Stonebridge Commons Residential Development Waterbury, Connecticut

King's Mark Environmental Review Team Report

Environmental Review Team Report

**Inland Wetlands and Watercourses Commission
Waterbury, Connecticut**

Figure One

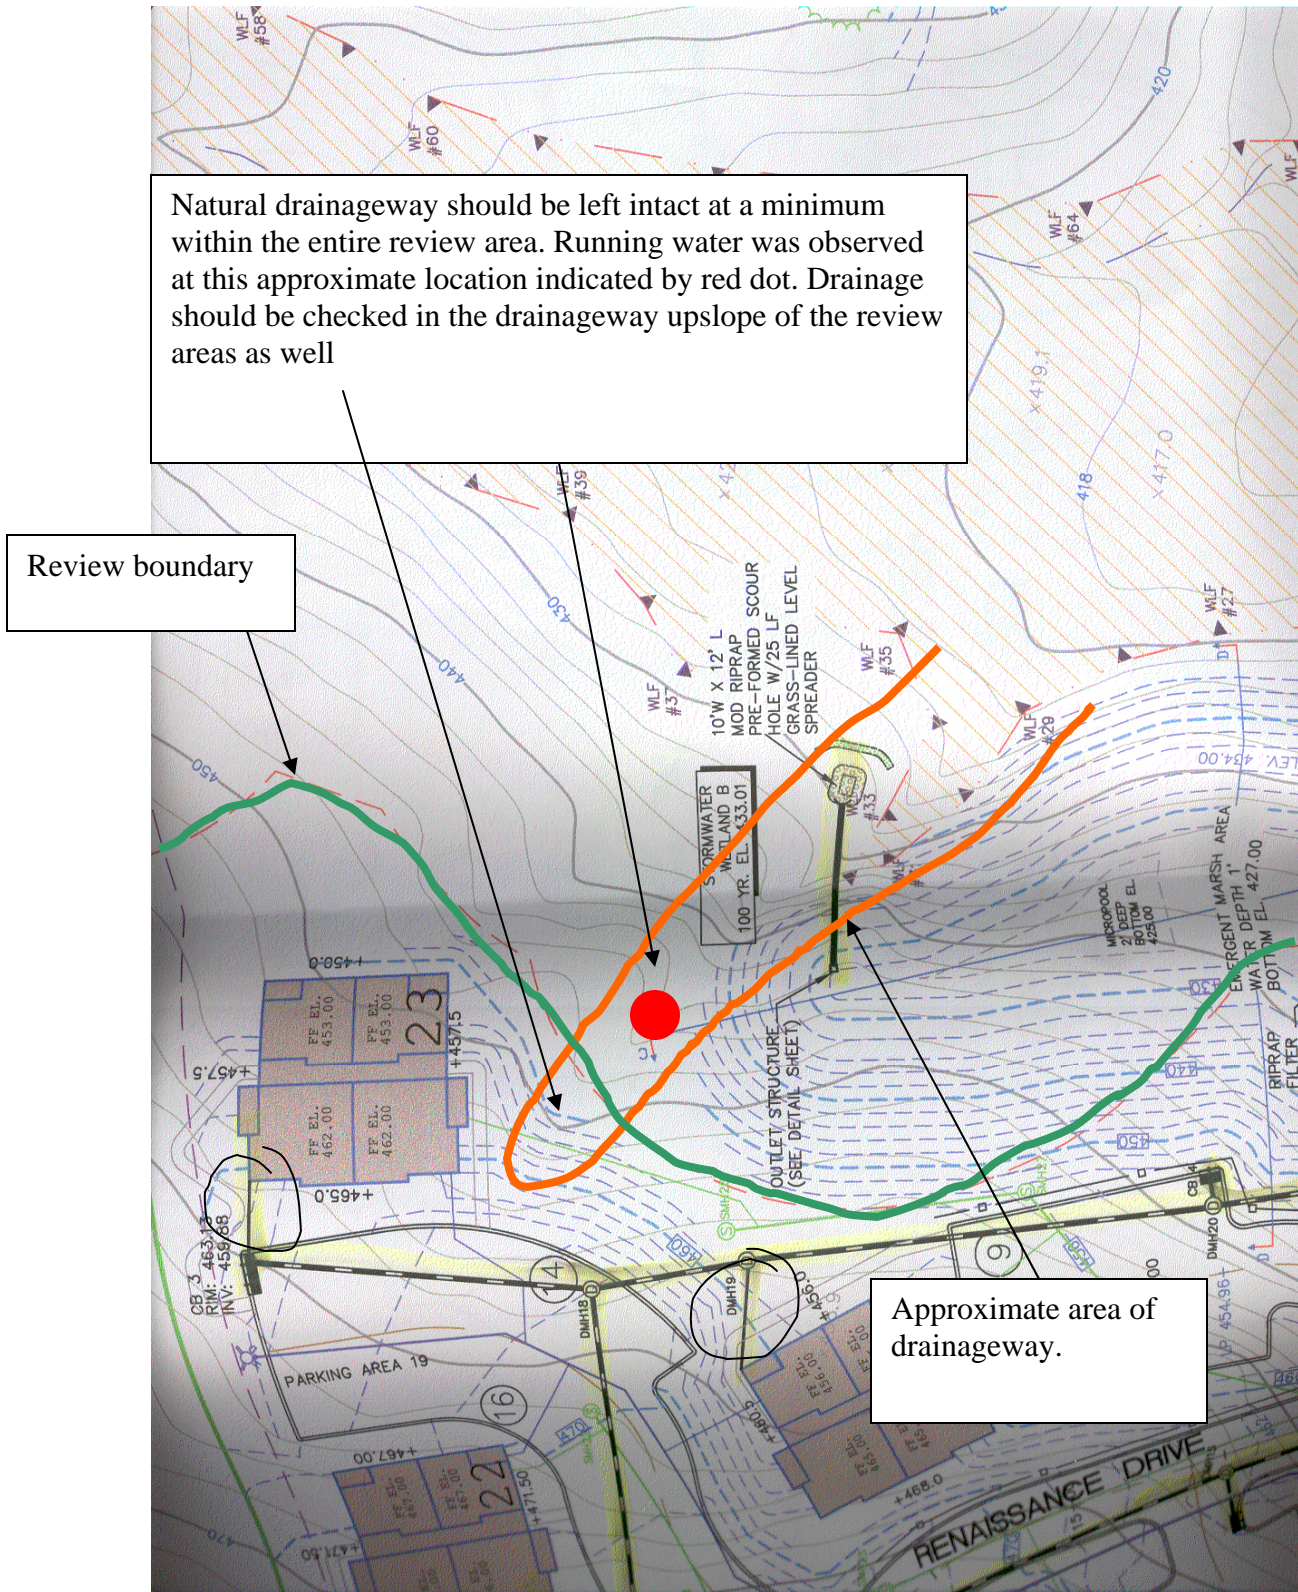
- 5) Drainageways should not be filled or disturbed (**See Figure One**). In particular the area as indicated in **Figure One** was found to have some running water during the site review field inspection. Drainageways can be used to convey stormwater, but stormwater structures and other development should not intrude into the drainageways. Stormwater should be treated before entering the natural drainageways and outflow should be moderated to duplicate natural flow conditions.

Photo Two: Highland Ave. Drainage. Looking North From Point A on **Figure 4**. Drainage crosses factory driveway and discharges directly into stream on south side of driveway. Note travel over soils disturbed by road traffic.

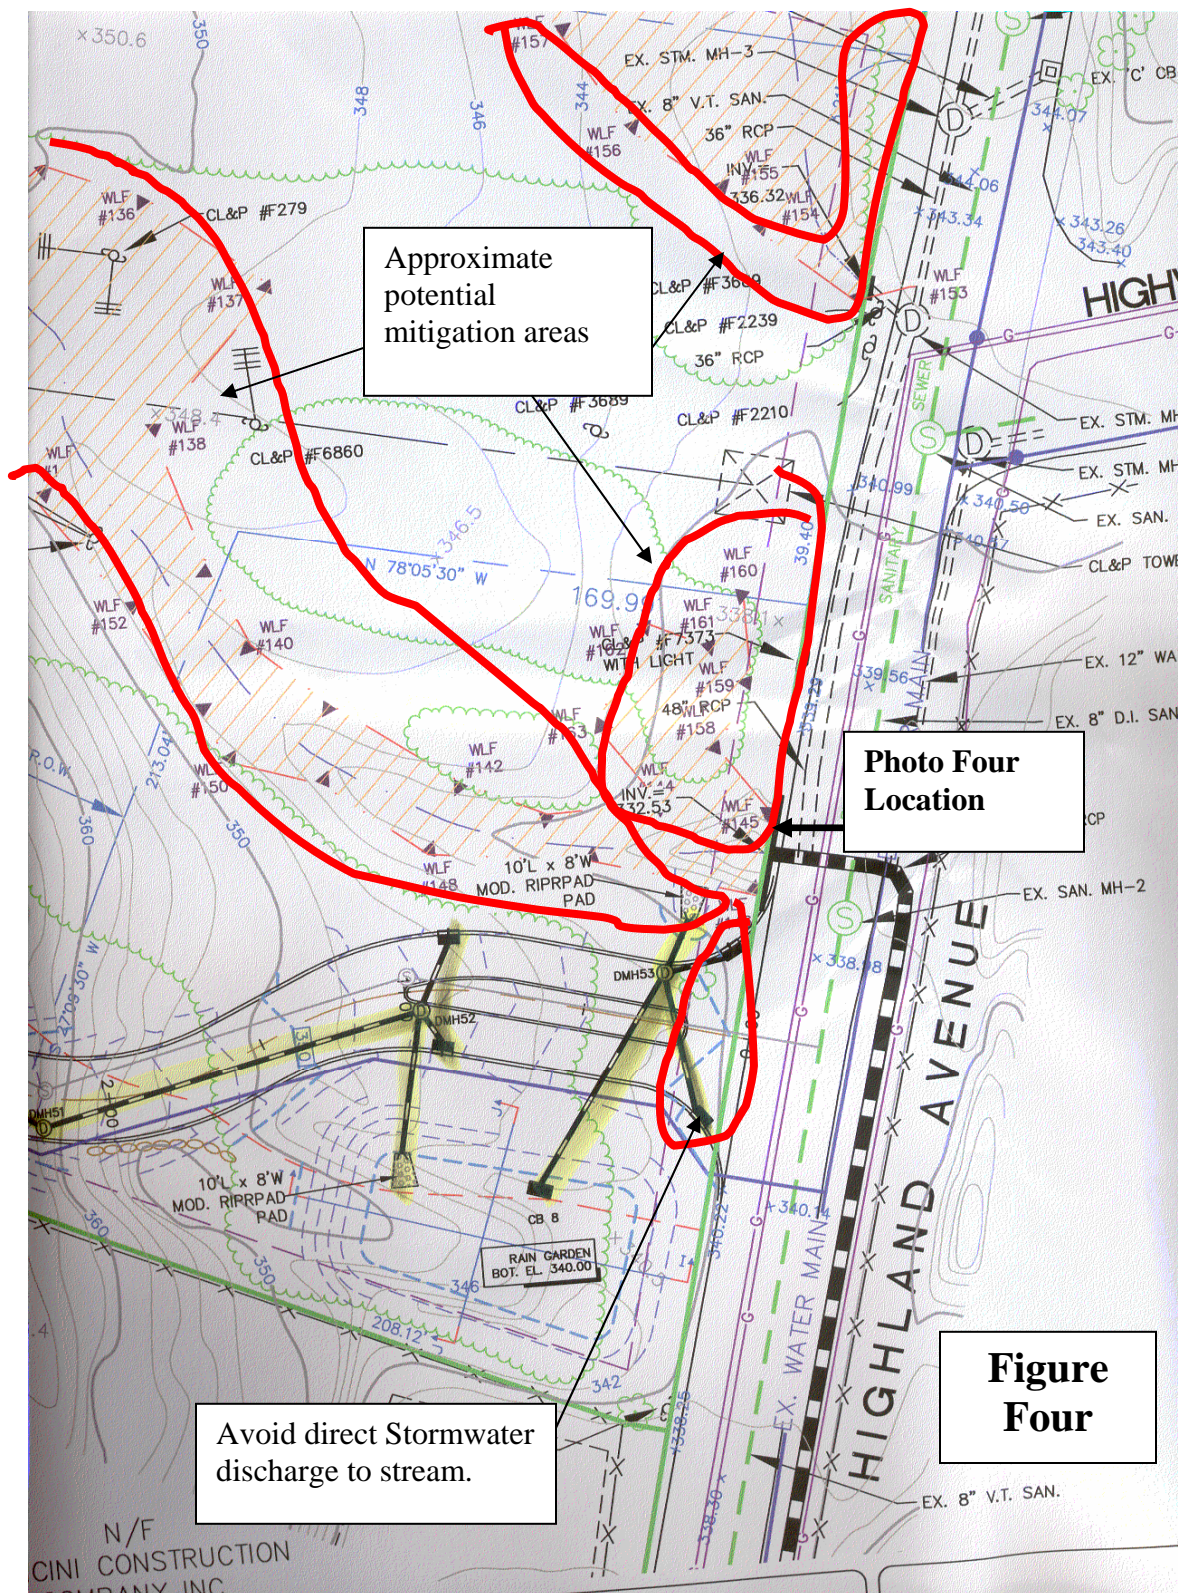
Creating mitigation in these already compromised areas will minimize the disturbance required in established upland forested areas and enhance water quality and riparian habitat of the stream. Also, the erosion near the Highland Avenue stream crossing point needs to be addressed to prevent damage to the road and as well as address the Stormwater running into the road as indicated in **Photo Three**.

Photo Three: Drainage on Highland Avenue just north of proposed road entrance to project. Drainage here includes stormwater that by passes factory driveway (up past the street sign) as shown in **Photo Two**. Note that there does appear to be some erosion along the edge of the pavement.

Photo Four: (Point A on Figure Four). Note sediment on pavement in foreground, eroded soil and damaged pavement at culvert headwall (Photo looks west).

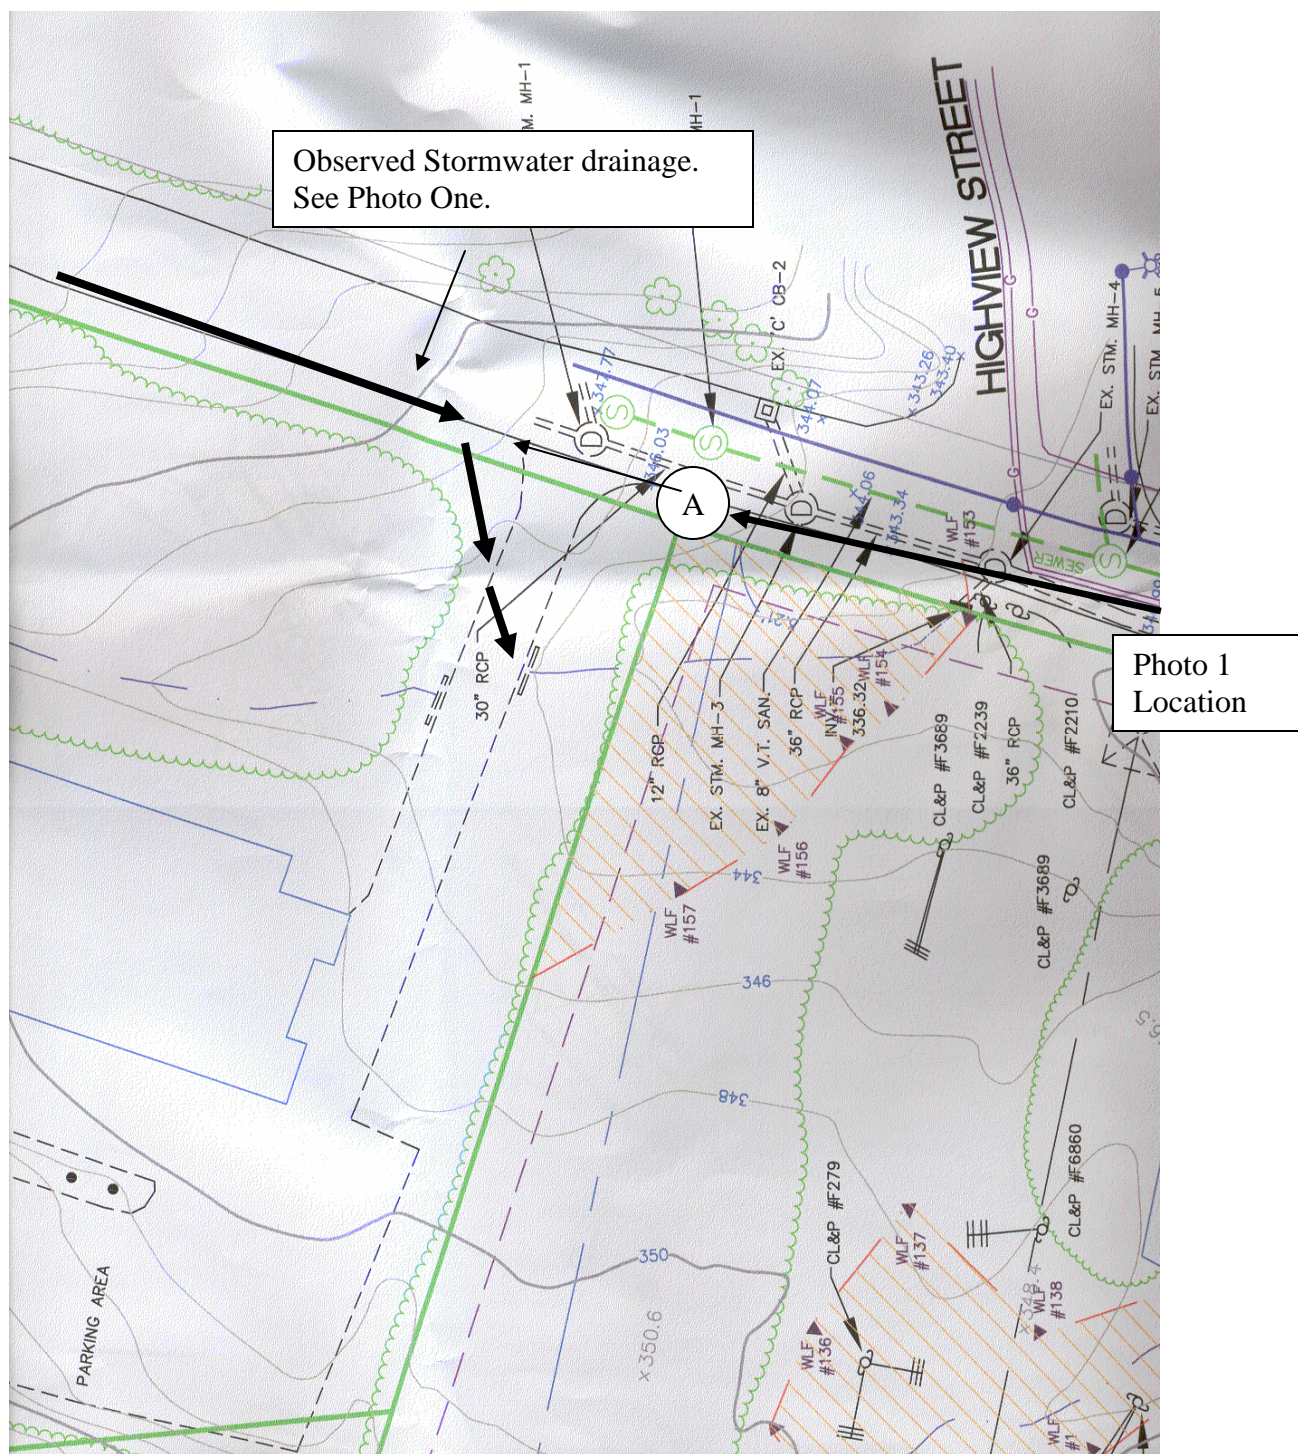
Existing areas of erosion such as indicated in **Photos Four and Five** should be stabilized and planted with appropriate native species. A Bioretention swale for the stormwater runoff from Highland Avenue could be created in the area as shown in **Photo Three and**

Photo Five: Looking west northwest from culvert headwall at Highland Avenue. Note erosion from pavement runoff as shown in **Photo Four** in lower right corner. Also note erosion from overland flow above headwall in photo (in red).

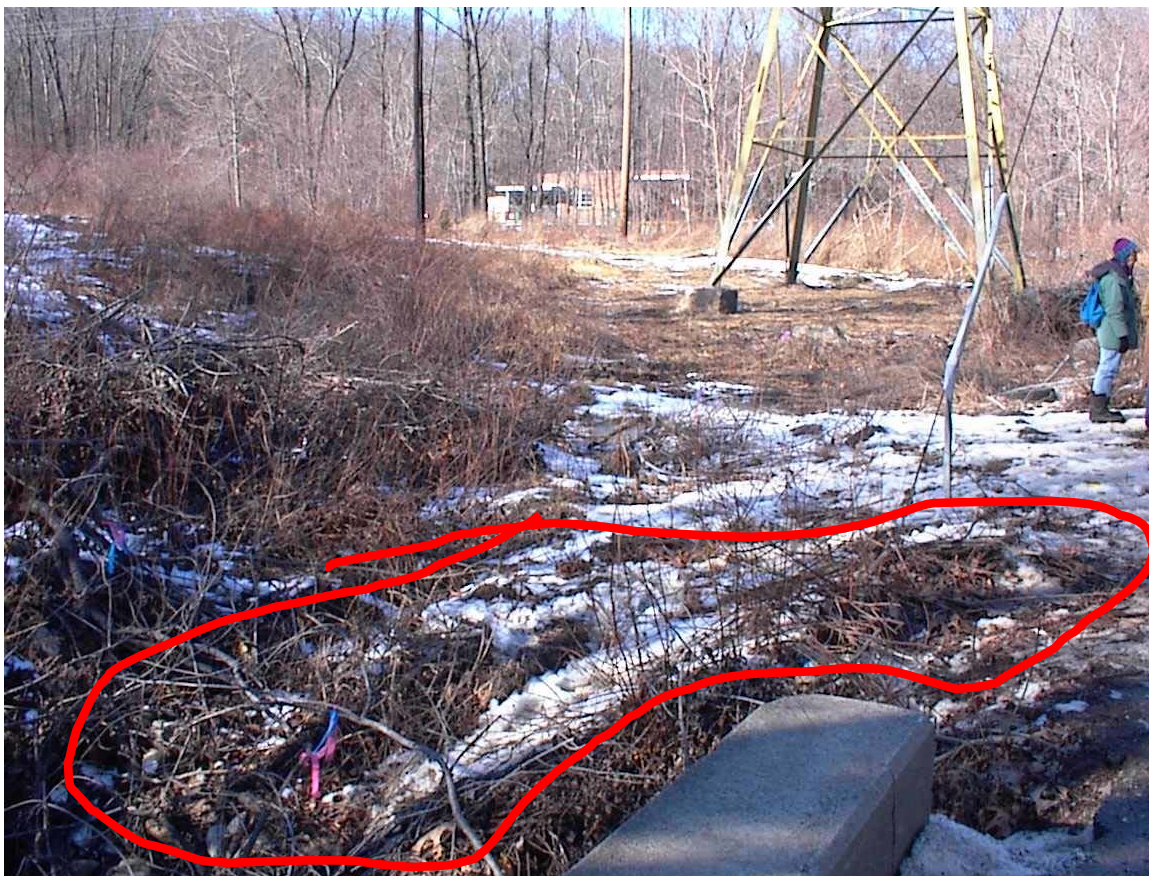
Photo Six: Looking South at Highland Avenue stream crossing. Red line is approximate location of proposed access road to project. 10 feet minimum of natural vegetation should remain between top of bank and disturbance for road. The stormwater treatment structure should be on the streamside of the proposed road to make the open area contiguous and to provide a buffer from road use.
